Reply to Associate Editor and Reviewers

“This work presents a boundary optimal control strategy for axial tubular reactors with first-order irreversible chemical reaction incorporating a delayed recycle stream. The mathematical description takes the form of a system of coupled parabolic and hyperbolic PDEs. An infinite-dimensional approach is applied to derive a linear quadratic regulator with and without observer. Numerical studies show that the proposed controller is able to stabilize the system. The manuscript is clear and well written and addresses a challenging control problem in chemical engineering. The following comments and suggestions may improve the presentation so that it is considered for publication.”

Figure 1: Concentration profile along the recycle stream

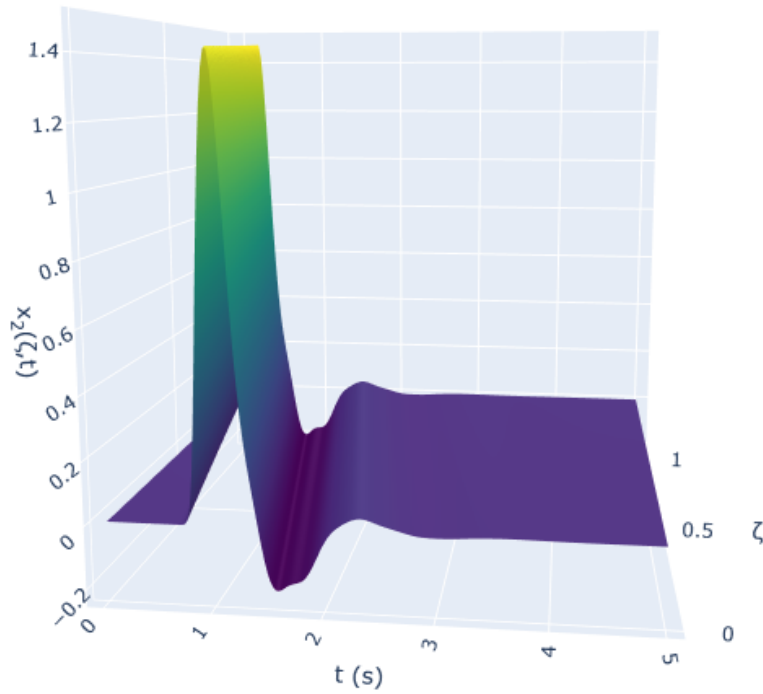
6. Page 7 - “ $x_2(\zeta, t)$ is introduced as a new state variable to account for the concentration along the recycle stream”

- Why is x_2 a function of ζ ? How does x_2 change across the recycle? What kind of law does it follow? To me, it seems like x_2 only changes with respect to time

We have assumed that along the recycle stream, the flow of the reactant belongs to the class of pure transport PDEs. This is the case when diffusion term and reaction term become negligible compared to the convective term, and the state variable x_2 is merely being transported along the recycle stream. Nevertheless, this still means that x_2 is a function of ζ and t . Concentration profile along the recycle stream has not been presented in the original submission as we believe it is not the focus of this work. However, for the reviewer's reference, it is included here in the response as shown in Fig. 1.
